Contract No. T201907404.01
Federal Aid Project No. NH-N059(46)
Rehabilitation of I-95, Bearing Replacements
New Castle County

Enclosed is Addendum No. 4 for the referenced contract consisting of the following:

CONCRETE REPAIR DETAILS
 & SUMMARY OF PROPOSED
 REPAIR & RECONSTR. ITEMS

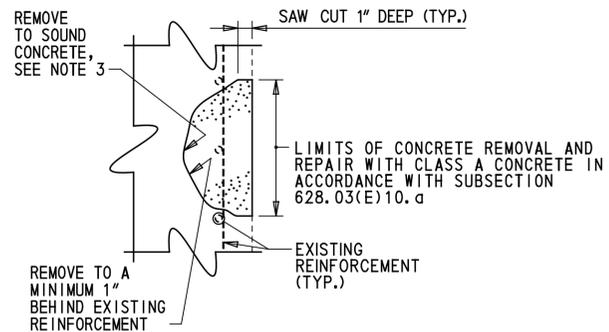
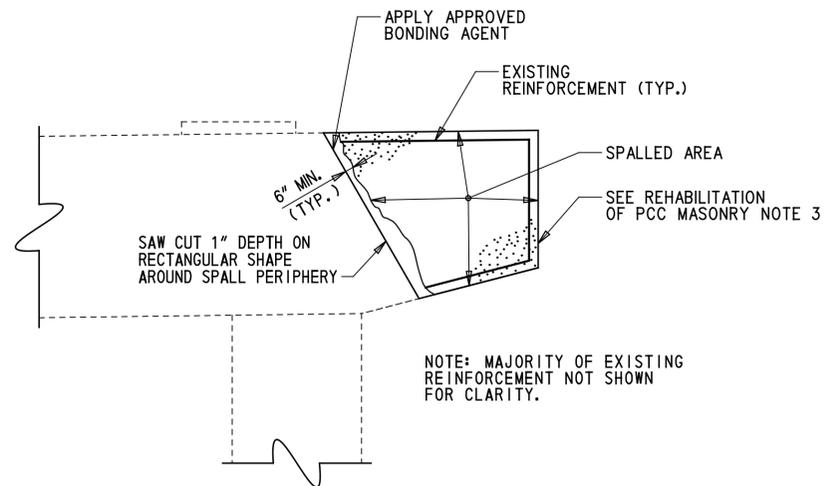
DEEP SPALL REPAIR (ITEM 628041)

REHABILITATION OF PCC MASONRY (ITEM 628042)

3. DETAIL SHOWN FOR "REHABILITATION OF EXISTING PCC MASONRY" UTILIZES A GENERIC EXAMPLE USING PARTIAL RECONSTRUCTION OF AN EXISTING PIER CAP. SEE PIER REHABILITATION SHEETS FOR SIZE AND LOCATION OF REPAIRS AT EACH SUBSTRUCTURE UNIT.

4. IF DEPTH OF REPAIR EXTENDS MORE THAN 6" BEYOND SURFACE OF CONCRETE, CONTRACTOR SHALL STOP WORK AND NOTIFY THE ENGINEER IMMEDIATELY.
5. FOR ANY WORK INCLUDED UNDER REHABILITATION OF PCC MASONRY TO TAKE PLACE WITHIN THE SPLASH ZONE OR UNDERWATER, THE CONTRACTOR SHALL SUBMIT A WORKING DRAWING IN ACCORDANCE WITH SUBSECTION 628.03(E)(2).

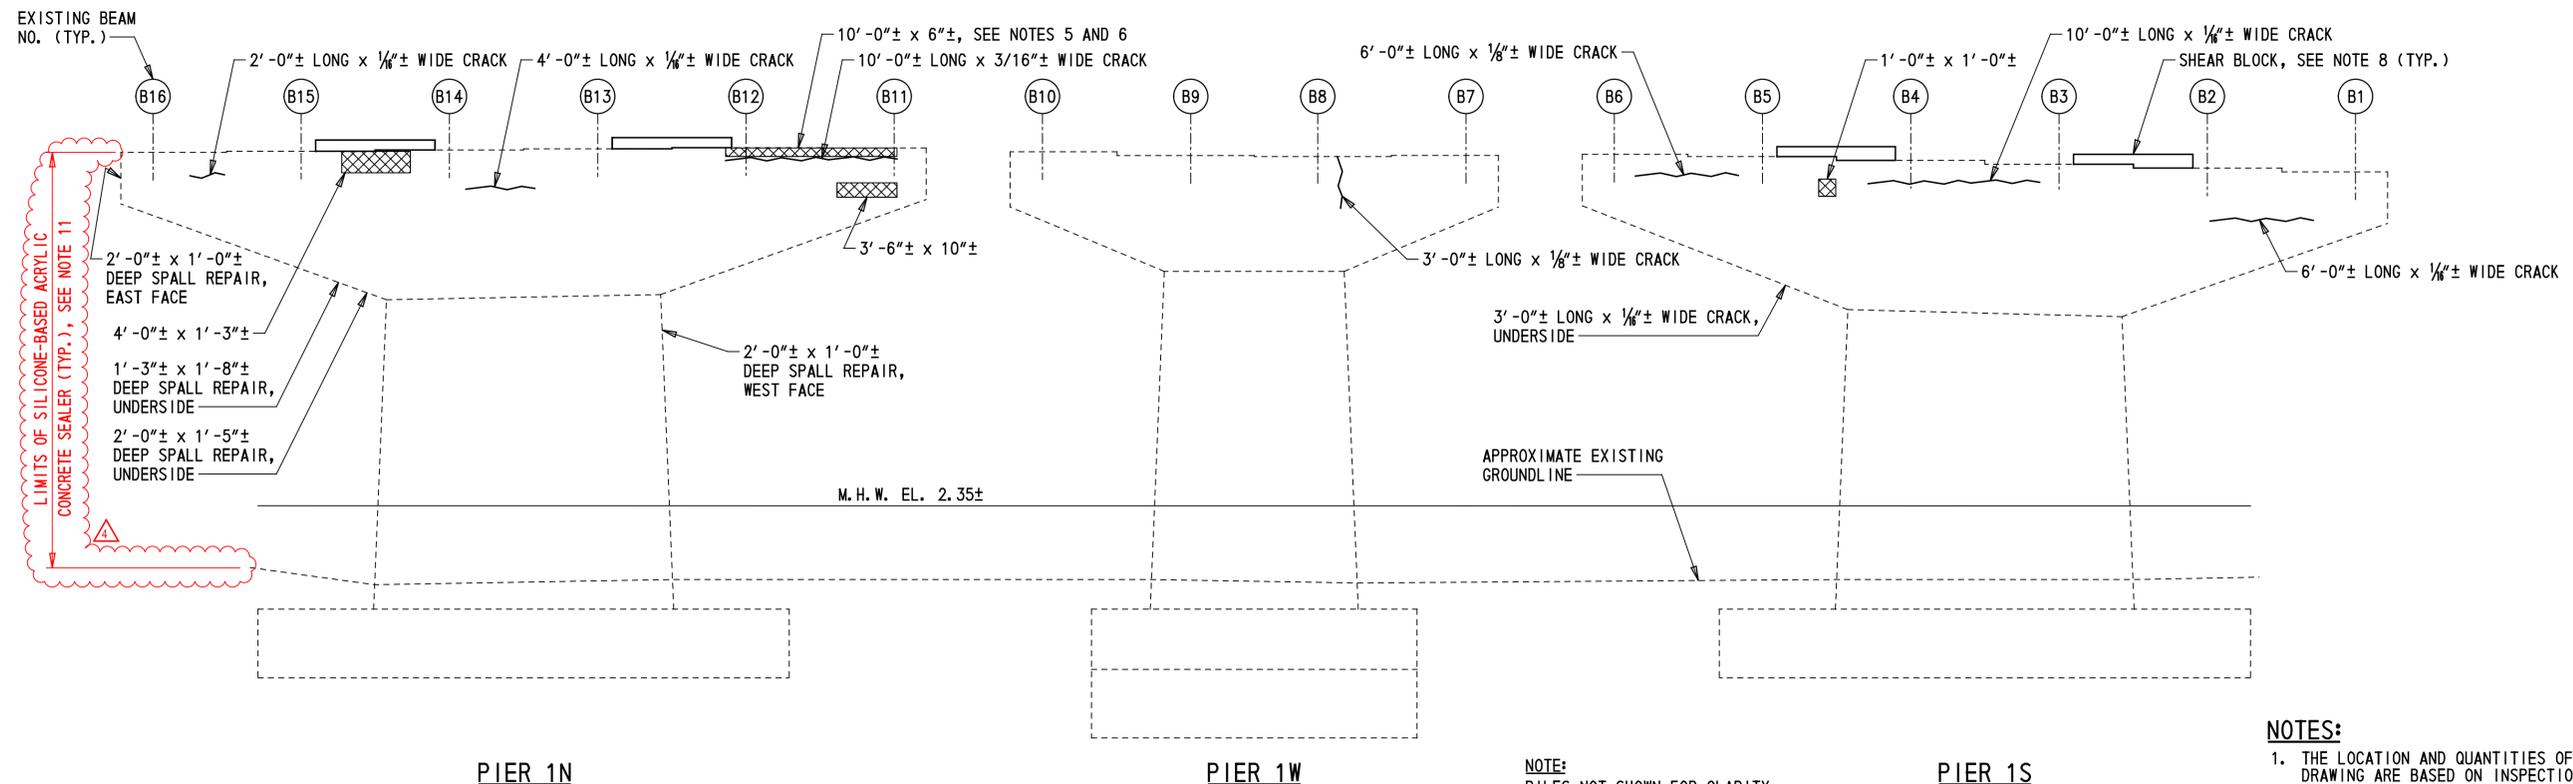
ADDENDA / REVISIONS
△ ADDED SUBSTRUCTURE REPAIR NOTES - C. MALKIN 3/2/2020

1. THE LOCATION AND QUANTITIES OF THE REPAIRS SHOWN ON THIS DRAWING ARE BASED ON INSPECTION NOTES (SEE NOTE 9 ON DWG. PN-01) AND ARE APPROXIMATE AND REQUIRE FIELD VERIFICATION. PRIOR TO STARTING EACH REPAIR, THE LIMITS SHALL BE VERIFIED BY THE CONTRACTOR IN THE PRESENCE OF THE ENGINEER.

2. WHERE CRACKS AND SPALLS/DELAMINATIONS EXIST CONCURRENTLY, COMPLETE THE SPALL REPAIR COMPLETELY REMOVING THE ASSOCIATED CRACK. IF THE CRACK EXTENDS LESS THAN 1'-0" BEYOND THE LIMITS OF THE SPALL REPAIR, EXTEND THE LIMITS OF THE SPALL REPAIR TO ENCOMPASS THE CRACK. IF THE CRACK EXTENDS DEEPER THAN THE LIMITS OF CONCRETE REMOVAL, THE CONTRACTOR SHALL REMOVE ADDITIONAL CONCRETE UNTIL THE CRACK IS FULLY REMOVED. IF THE DEPTH OF REMOVAL REACHES MORE THAN 6" FROM THE ORIGINAL FACE OF CONCRETE, ALL WORK ON THE REPAIR SHALL STOP AND THE ENGINEER SHALL BE NOTIFIED IMMEDIATELY. IF THE CRACK EXTENDS MORE THAN 1'-0" BEYOND THE LIMITS OF THE SPALL REPAIR INTO SOUND CONCRETE THE CRACK SHALL BE REPAIRED BY EPOXY INJECTION BEYOND THE LIMITS OF THE SPALL REPAIR AND PAID FOR UNDER ITEM 628001 - REPAIR OF CONCRETE STRUCTURES BY EPOXY INJECTION. PAYMENT FOR CRACK REMOVAL LOCATED WITHIN SPALL REPAIRS WILL BE CONSIDERED INCIDENTAL TO ITEM 628041 - DEEP SPALL REPAIR.

8. FOR SHEAR BLOCK DETAILS, SEE DWG. PR-09.
9. EPOXY CONCRETE SEALER SHALL BE APPLIED TO THE BEAM SEATS AND BEARING PEDESTALS. PAYMENT WILL BE MADE UNDER ITEM 613000 - EPOXY CONCRETE SEALER. CONTRACTOR SHALL REMOVE DEBRIS FROM THE BEAM SEAT PRIOR TO APPLICATION OF EPOXY CONCRETE SEALER. PAYMENT FOR THIS WORK WILL BE INCIDENTAL TO ITEM 613000 - EPOXY CONCRETE SEALER.

10. CONTRACTOR SHALL TAKE CARE TO PROTECT THE BEARINGS DURING APPLICATION OF THE EPOXY CONCRETE SEALER. ANY CLEAN-UP REQUIRED TO REMOVE THE SEALER FROM THE BEARINGS WILL BE AT NO ADDITIONAL COST TO THE DEPARTMENT AND TO THE SATISFACTION OF THE ENGINEER.

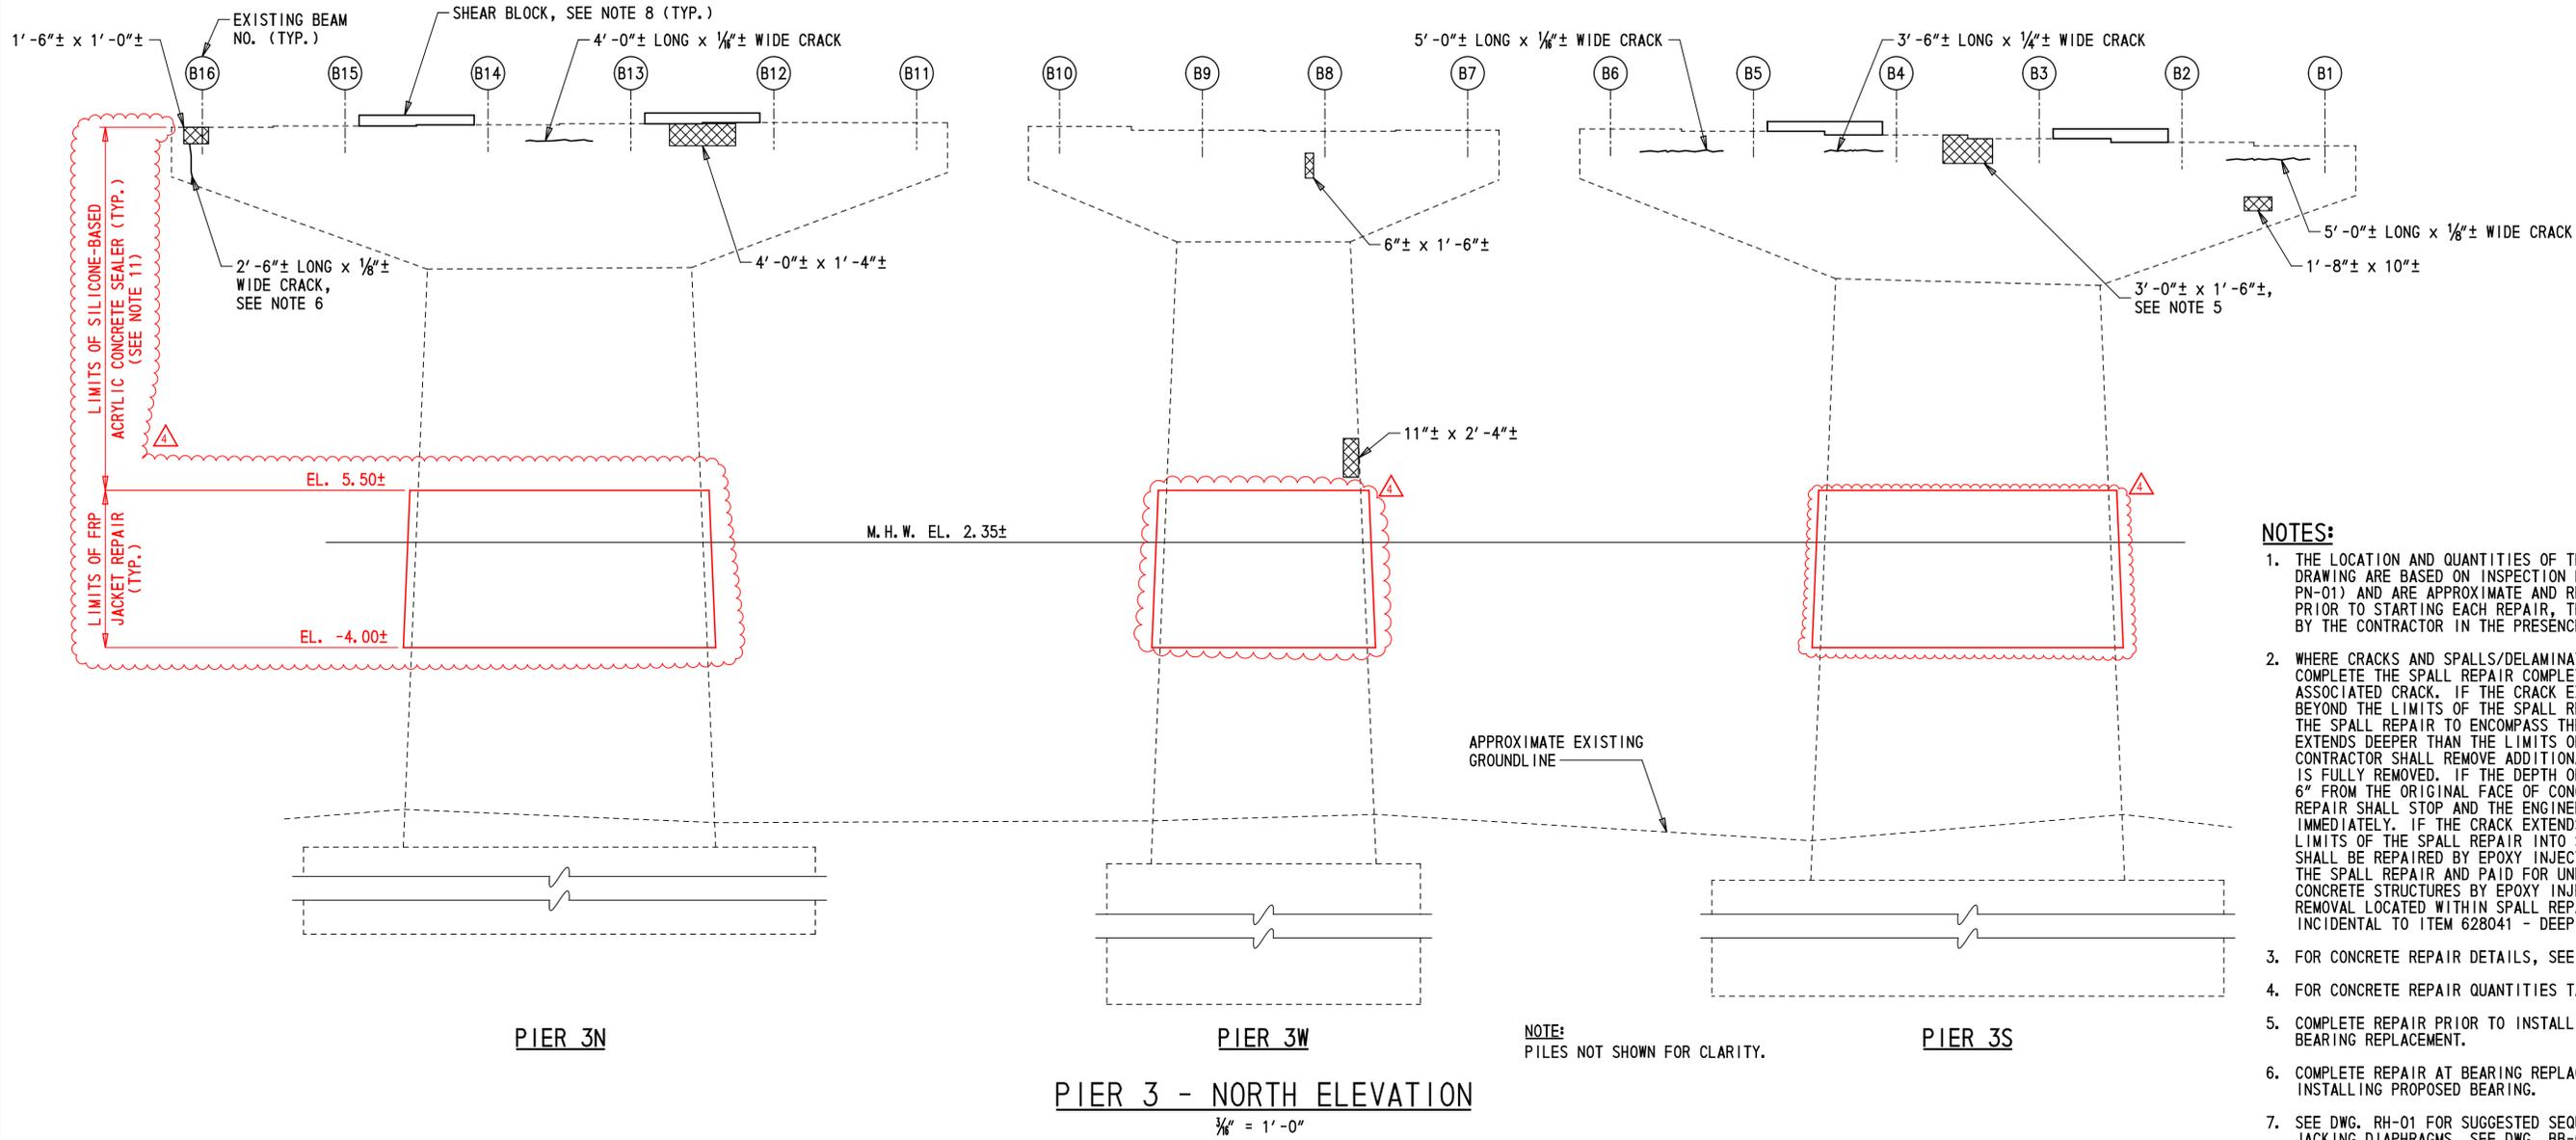
ADDENDA / REVISIONS
 △ ADDED SUBSTRUCTURE REPAIR NOTES - C. MALKIN 3/2/2020

- NOTES:**
1. THE LOCATION AND QUANTITIES OF THE REPAIRS SHOWN ON THIS DRAWING ARE BASED ON INSPECTION NOTES (SEE NOTE 9 ON DWG. PN-01) AND ARE APPROXIMATE AND REQUIRE FIELD VERIFICATION. PRIOR TO STARTING EACH REPAIR, THE LIMITS SHALL BE VERIFIED BY THE CONTRACTOR IN THE PRESENCE OF THE ENGINEER.

2. WHERE CRACKS AND SPALLS/DELAMINATIONS EXIST CONCURRENTLY, COMPLETE THE SPALL REPAIR COMPLETELY REMOVING THE ASSOCIATED CRACK. IF THE CRACK EXTENDS LESS THAN 1'-0" BEYOND THE LIMITS OF THE SPALL REPAIR, EXTEND THE LIMITS OF THE SPALL REPAIR TO ENCOMPASS THE CRACK. IF THE CRACK EXTENDS DEEPER THAN THE LIMITS OF CONCRETE REMOVAL, THE CONTRACTOR SHALL REMOVE ADDITIONAL CONCRETE UNTIL THE CRACK IS FULLY REMOVED. IF THE DEPTH OF REMOVAL REACHES MORE THAN 6" FROM THE ORIGINAL FACE OF CONCRETE, ALL WORK ON THE REPAIR SHALL STOP AND THE ENGINEER SHALL BE NOTIFIED IMMEDIATELY. IF THE CRACK EXTENDS MORE THAN 1'-0" BEYOND THE LIMITS OF THE SPALL REPAIR INTO SOUND CONCRETE THE CRACK SHALL BE REPAIRED BY EPOXY INJECTION BEYOND THE LIMITS OF THE SPALL REPAIR AND PAID FOR UNDER ITEM 628001 - REPAIR OF CONCRETE STRUCTURES BY EPOXY INJECTION. PAYMENT FOR CRACK REMOVAL LOCATED WITHIN SPALL REPAIRS WILL BE CONSIDERED INCIDENTAL TO ITEM 628041 - DEEP SPALL REPAIR.

8. FOR SHEAR BLOCK DETAILS, SEE DWG. PR-09.
 9. EPOXY CONCRETE SEALER SHALL BE APPLIED TO THE BEAM SEATS AND BEARING PEDESTALS. PAYMENT WILL BE MADE UNDER ITEM 613000 - EPOXY CONCRETE SEALER. CONTRACTOR SHALL REMOVE DEBRIS FROM THE BEAM SEAT PRIOR TO APPLICATION OF EPOXY CONCRETE SEALER. PAYMENT FOR THIS WORK WILL BE INCIDENTAL TO ITEM 613000 - EPOXY CONCRETE SEALER.

10. CONTRACTOR SHALL TAKE CARE TO PROTECT THE BEARINGS DURING APPLICATION OF THE EPOXY CONCRETE SEALER. ANY CLEAN-UP REQUIRED TO REMOVE THE SEALER FROM THE BEARINGS WILL BE AT NO ADDITIONAL COST TO THE DEPARTMENT AND TO THE SATISFACTION OF THE ENGINEER.

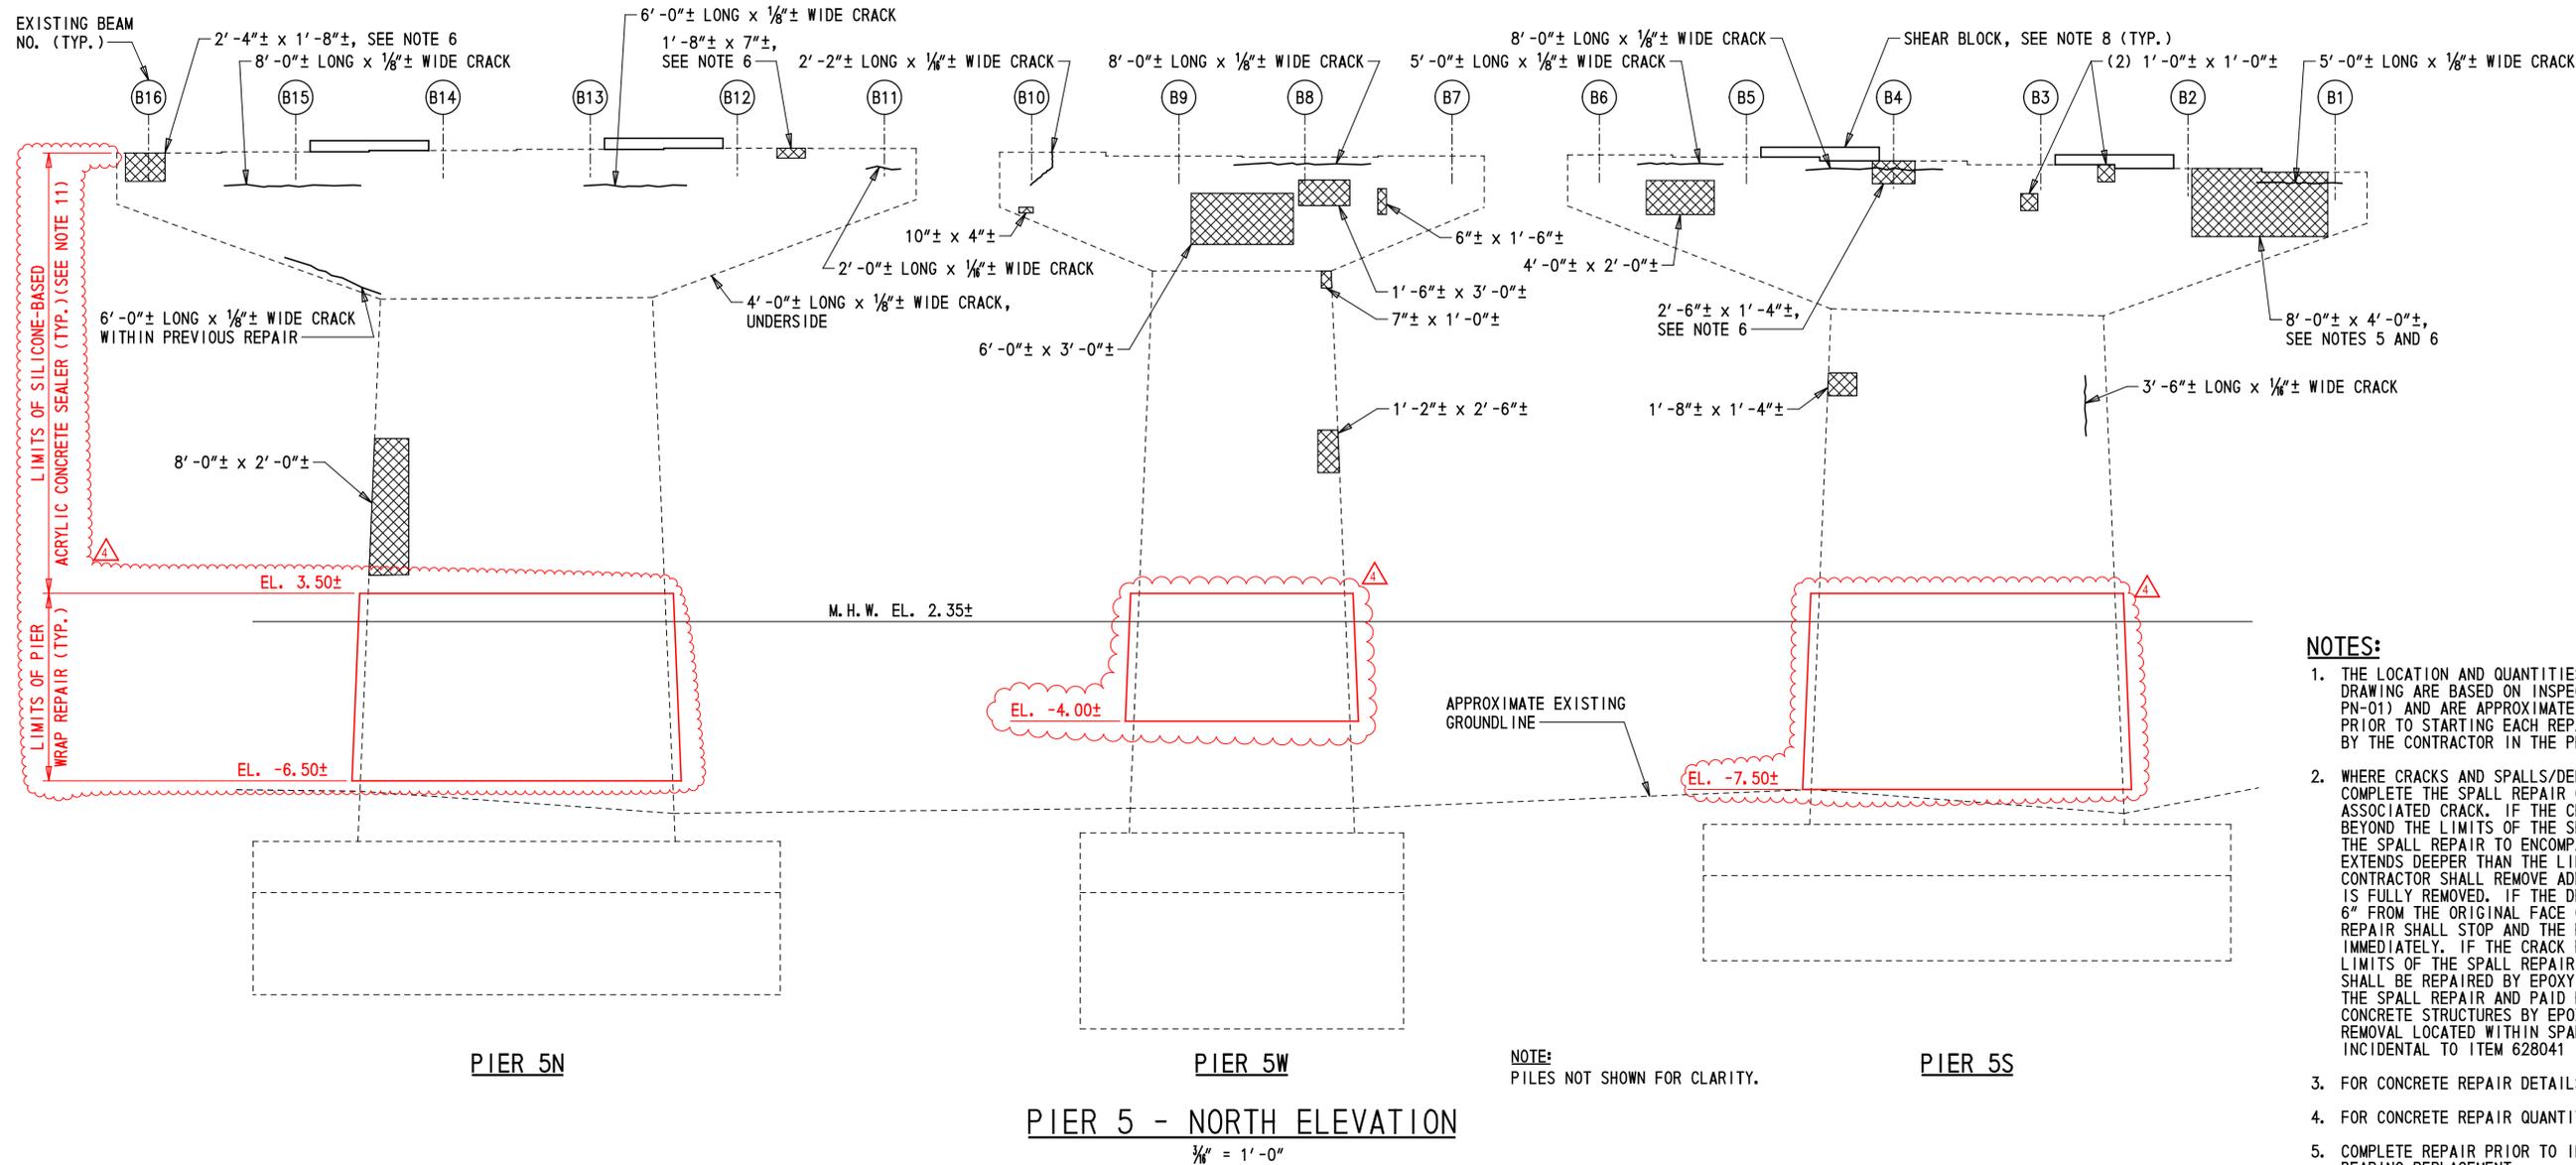
ADDENDA / REVISIONS
1. ADDED SUBSTRUCTURE REPAIR NOTES - C. MALKIN 3/2/2020

- NOTES:**
1. THE LOCATION AND QUANTITIES OF THE REPAIRS SHOWN ON THIS DRAWING ARE BASED ON INSPECTION NOTES (SEE NOTE 9 ON DWG. PN-01) AND ARE APPROXIMATE AND REQUIRE FIELD VERIFICATION. PRIOR TO STARTING EACH REPAIR, THE LIMITS SHALL BE VERIFIED BY THE CONTRACTOR IN THE PRESENCE OF THE ENGINEER.

2. WHERE CRACKS AND SPALLS/DELAMINATIONS EXIST CONCURRENTLY, COMPLETE THE SPALL REPAIR COMPLETELY REMOVING THE ASSOCIATED CRACK. IF THE CRACK EXTENDS LESS THAN 1'-0" BEYOND THE LIMITS OF THE SPALL REPAIR, EXTEND THE LIMITS OF THE SPALL REPAIR TO ENCOMPASS THE CRACK. IF THE CRACK EXTENDS DEEPER THAN THE LIMITS OF CONCRETE REMOVAL, THE CONTRACTOR SHALL REMOVE ADDITIONAL CONCRETE UNTIL THE CRACK IS FULLY REMOVED. IF THE DEPTH OF REMOVAL REACHES MORE THAN 6" FROM THE ORIGINAL FACE OF CONCRETE, ALL WORK ON THE REPAIR SHALL STOP AND THE ENGINEER SHALL BE NOTIFIED IMMEDIATELY. IF THE CRACK EXTENDS MORE THAN 1'-0" BEYOND THE LIMITS OF THE SPALL REPAIR INTO SOUND CONCRETE THE CRACK SHALL BE REPAIRED BY EPOXY INJECTION BEYOND THE LIMITS OF THE SPALL REPAIR AND PAID FOR UNDER ITEM 628001 - REPAIR OF CONCRETE STRUCTURES BY EPOXY INJECTION. PAYMENT FOR CRACK REMOVAL LOCATED WITHIN SPALL REPAIRS WILL BE CONSIDERED INCIDENTAL TO ITEM 628041 - DEEP SPALL REPAIR.

8. FOR SHEAR BLOCK DETAILS, SEE DWG. PR-09.
 9. EPOXY CONCRETE SEALER SHALL BE APPLIED TO THE BEAM SEATS AND BEARING PEDESTALS. PAYMENT WILL BE MADE UNDER ITEM 613000 - EPOXY CONCRETE SEALER. CONTRACTOR SHALL REMOVE DEBRIS FROM THE BEAM SEAT PRIOR TO APPLICATION OF EPOXY CONCRETE SEALER. PAYMENT FOR THIS WORK WILL BE INCIDENTAL TO ITEM 613000 - EPOXY CONCRETE SEALER.

10. CONTRACTOR SHALL TAKE CARE TO PROTECT THE BEARINGS DURING APPLICATION OF THE EPOXY CONCRETE SEALER. ANY CLEAN-UP REQUIRED TO REMOVE THE SEALER FROM THE BEARINGS WILL BE AT NO ADDITIONAL COST TO THE DEPARTMENT AND TO THE SATISFACTION OF THE ENGINEER.
